January 15, 2018  
WO 18-0004

Subject: Docket No. 50-482: Response to Request for Additional Information Regarding License Amendment Request to Revise Technical Specifications to Transition to Westinghouse Core Design and Safety Analysis Including Adoption of Alternative Source Term

## Response to Request for Additional Information

**Enclosure I to Attachment I  
(2 pages)**

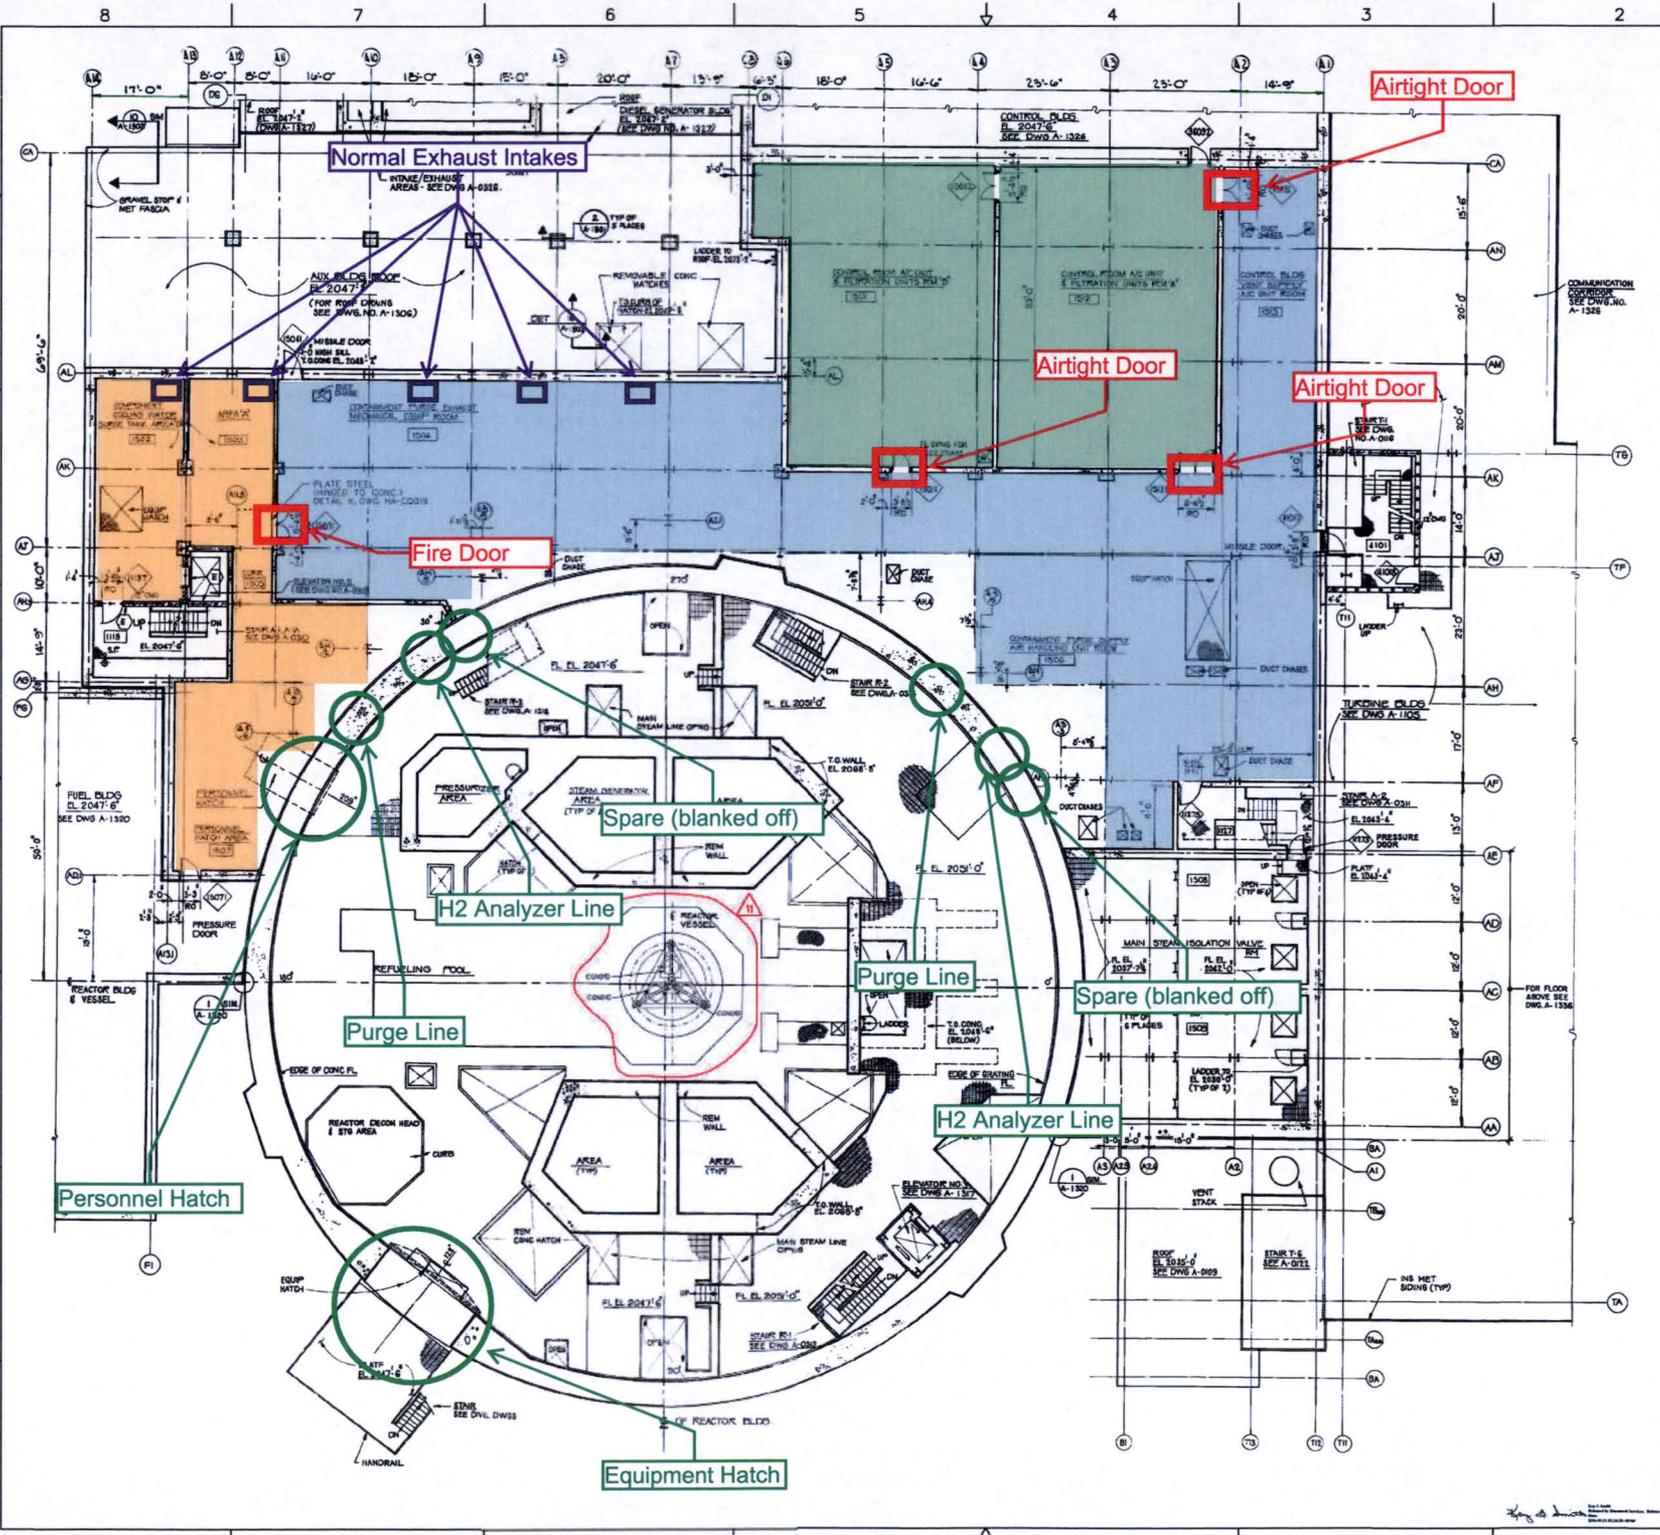
1. *Please provide justification for the assumptions made regarding the flows assumed into the auxiliary building, the dilution volume credited for the auxiliary building, and the unfiltered inleakage into the control room considering the possible environmental conditions due to winds entering the open containment penetrations or "stack effects" in the containment, or revise the assumptions and provide a justification for the new assumptions. Please consider all the different configurations for containment openings allowed by your TSs. Note that RG 1.183 allows mixing in other volumes such as the containment (up to 50 percent of the free volume) and the fuel building on a case-by-case basis, but no guidance exists for mixing in the auxiliary building.*

In order to aid the response to this question (as the accident is not typically analyzed in this manner), two figures have been enclosed with this Attachment (Enclosure I and Enclosure II). The first attachment shows a marked up floor plan of the relevant auxiliary building level. The second attachment shows all containment penetration locations.

In regards to "stack effects," as shown on Enclosure I and Enclosure II, the only two penetrations that would allow direct movement of air between the containment building and the outside environment are the equipment hatch and the auxiliary access hatch (also referred to as the emergency air lock). While the equipment hatch could be open following a FHA, as stated in the response documented within ET 17-0011 the emergency air lock will not be:

For the auxiliary building volume credited, Enclosure I shows which volumes were and were not considered. The open area between the containment and the CRE envelope is shown in blue and was credited as a mixing volume. As shown on the drawing, for simplicity and conservatism, the air volume directly next to the containment wall arc was neglected (shown in white). As the roof for this floor is 24 feet, the approximate volume of this area is greater than 178,000 ft<sup>3</sup>. This volume was reduced to 70,000 ft<sup>3</sup> to account for equipment as well as the percentage available for mixing.

As shown on Enclosure I and Enclosure II to this attachment, there are only 6 penetrations (besides the personnel air lock and the equipment hatch) above the 2047' Elevation. These six penetrations are for the purge lines (two penetrations), H<sup>2</sup> analyzer lines (two penetrations), and two blanked off spare locations. As described in the response to ARCB1-FHA-5, justification exists for crediting these penetrations as isolated during a FHA. Nevertheless, in order to conservatively account for these penetrations, a reduced mixing volume within the auxiliary building was modeled. As such, these penetrations are addressed by the analysis documented within ET 17-0011.
